RECALL CAMPAIGN BULLETIN

VOLUNTARY RECALL CAMPAIGN FMVSS CERTIFICATION LABEL TIRE PRESSURE INFORMATION

CAMPAIGN IDENTIFICATION NO: 90V-072

Figure 1

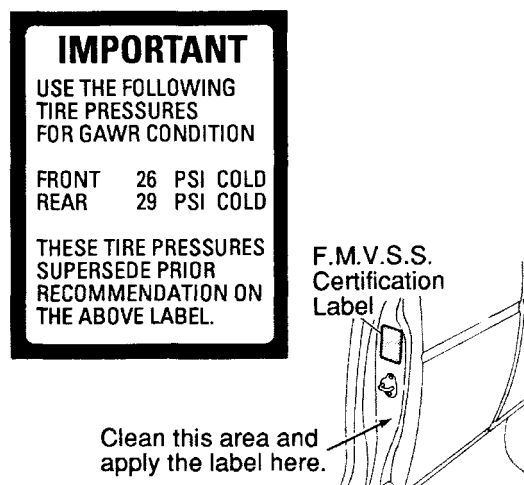
1. Before installing the new Tire Pressure Label, the left door frame just below the door latch striker must be cleaned. Using clean water and a dishwashing detergent, remove all dirt, oil and/or grease from the frame surface [Figure 1]
2. Thoroughly dry the area with a clean cloth
3. Apply the new Tire Pressure Label to the cleaned area [Figure 1]. To ensure proper adhesion, press firmly down on the center of the label, then wipe outward to the outer edges
